Update on the HBD Gas System Modifications

Robert Pisani

Brookhaven National Laboratory

July 29, 2008

Analyzer source moved

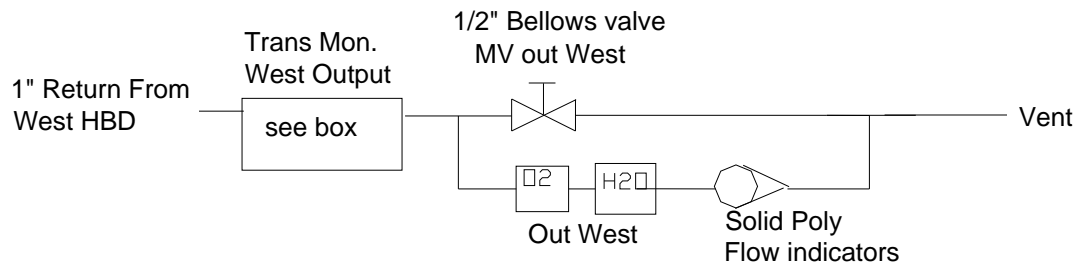
Source where HBD analyzer gas was being taped into was changed. The old setup (above) had 10-20% of the HBD return gas diverted to the analyzers and returned after the monitor (parallel system). I was asked to have all the gas first enter the Monitor and then pass it through the analyzers as in the original drawing. **-DONE**

New picture of the Hut

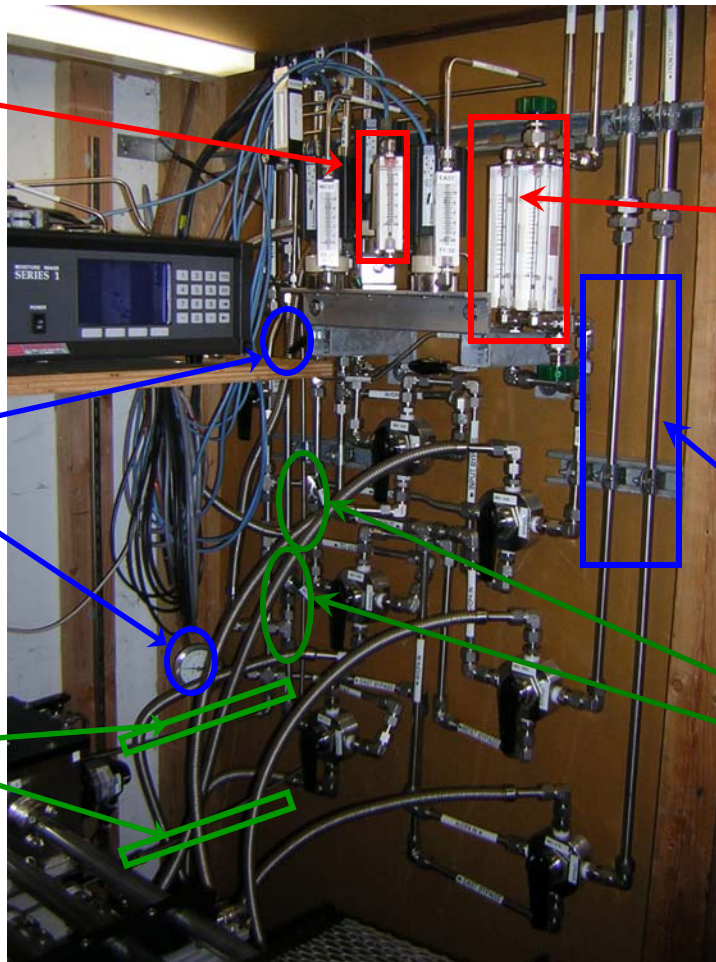
Old Flowmeter with built-in valve replaced with low impedance flow indicator to help reduce the pressure needed to feed the input analyzers.

1/4" turn Argon valve that feeds the monitor was replaced with multi-turn bellows valve. Vac-1Atm pressure gauge was installed to help bring the system to atm after pumping.

Replace 1/4" hard pipe feeding Ar to monitor with flex line

Old Flowmeters with built-in valves were replaced with low impedance flow indicator and separate higher Cv bellows valve

Choke valves to force flow to analyzers were here

New choke valve and tap location. 1/4" lines to analyzers replaced with 1/2" flex lines to help reduce pressure.

HBD Gas Rack

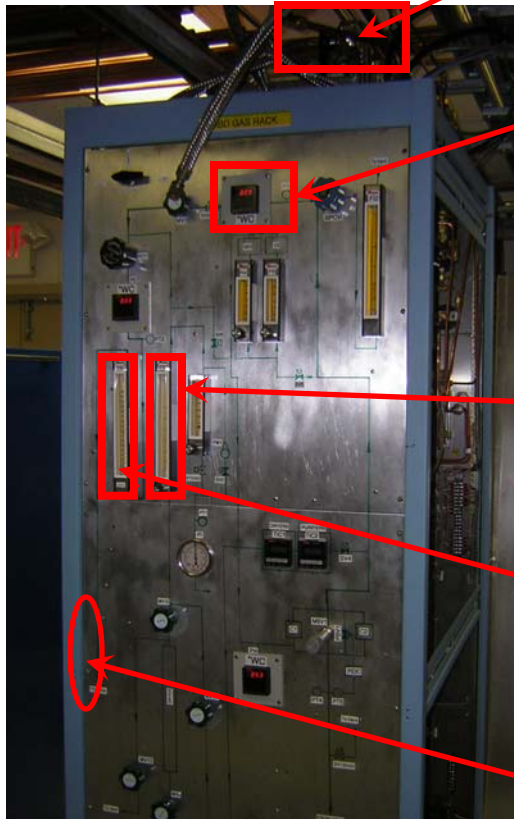
Solenoid valve to the vent had to be changed to accommodate much higher flow rate than designed (10x higher). Custom valve ordered and in hand

Pressure transmitter may need to be replaced. This was at upper reading limit in Run6. With the new flowmeters, the higher pressures in the rack may not be needed

Old flowmeter with built-in valves needs to be replaced with low impedance flow indicator and separate valve. This valve controls how much gas passes through the purifiers. Right now all gas pass through it. This flowmeter was already replaced once mid-Run6 to increase flow to the HBD

Old flowmeter without built-in valves needs to be replaced with low impedance flow indicator. This indicates how much total gas is going to the system. This flowmeter was already replaced once mid-Run6 to increase flow to the HBD. It need to be replace again for the higher flowrate.

Replace Purifier to handle the higher gas flow--**DONE**
